March 28 2016

TO: Department of Energy
U.S. Department of Energy
Office of Nuclear Energy, Response to IPC
1000 Independence Ave SW.
Washington, DC 20585
consentbasedsiting@hq.doe.gov

RE: Response to IPC – DOE's radioactive spent fuel storage plan is designed to leak

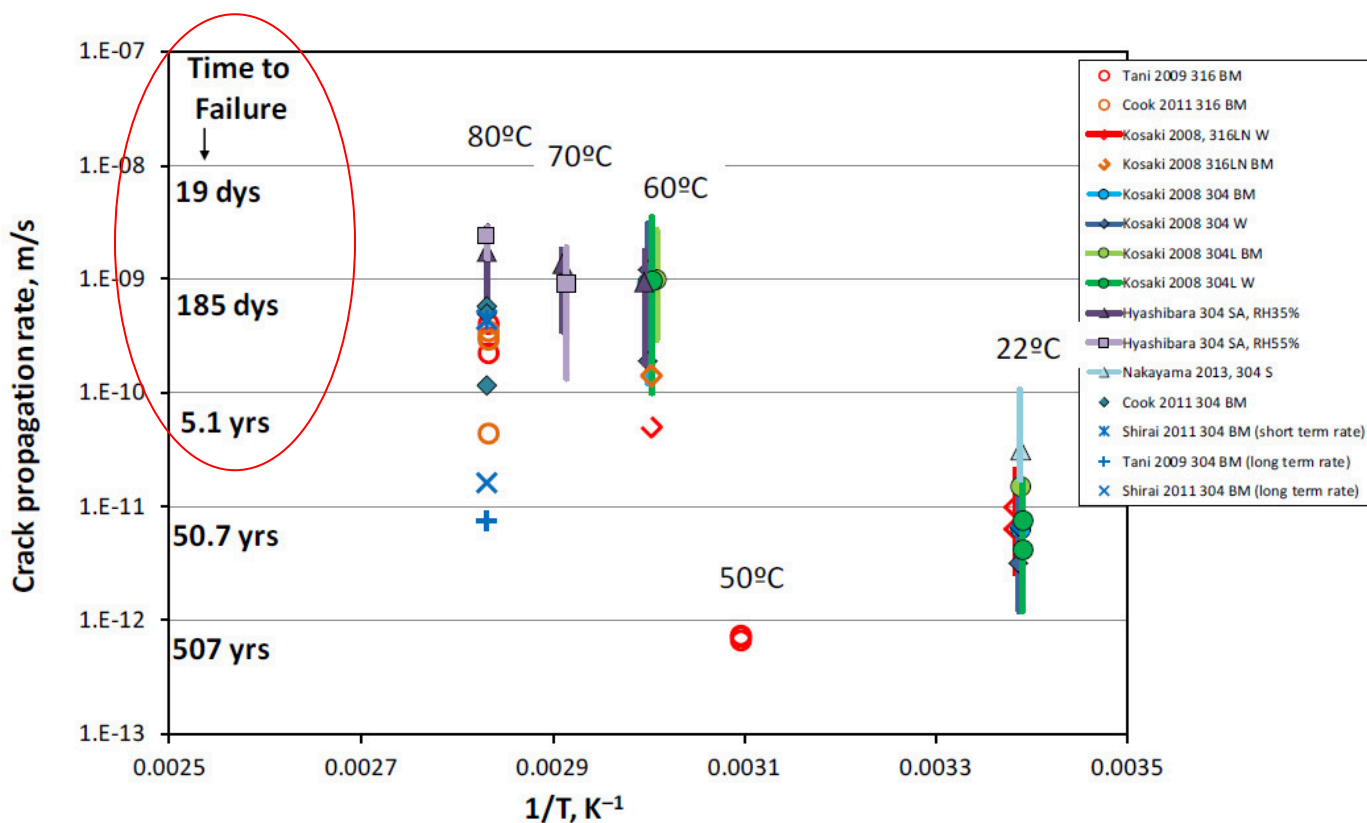
DOE pilot project is designed to fail and leak radiation: The proposed DOE irradiated spent fuel nuclear waste storage plan is designed to fail. It proposes transporting and storing existing thin-walled stainless steel canisters (1/2” to 5/8” thick) that cannot be inspected, repaired, maintained, have no early warning system prior to a radiation leak, can corrode and crack, and can start leaking millions of curies of radiation after 20 years of storage, possibly sooner. A 2015 Sandia Lab report shows that once cracks start in hotter thin-walled stainless steel canisters, they can grow through the wall of the canister in less than 5 years (Attachment - Sandia Chart).

Thin-walled stainless steel U.S. irradiated spent fuel storage canisters at higher temperatures will have faster crack growth rate. The Sandia Chart below shows higher temperatures can cause canisters to penetrate the wall in less than 5 years. This chart assumes canister wall is 0.625” (5/8”) thick. The majority of the U.S. canisters are only 0.50” (1/2”) thick. It is unknown when a crack will start, but these canisters are subject to corrosion and cracking from environmental conditions such as chloride salts, air pollution (sulfides), pitting, and microscopic scratches. The report states that canisters such as those at Diablo Canyon have temperatures in these heat ranges.
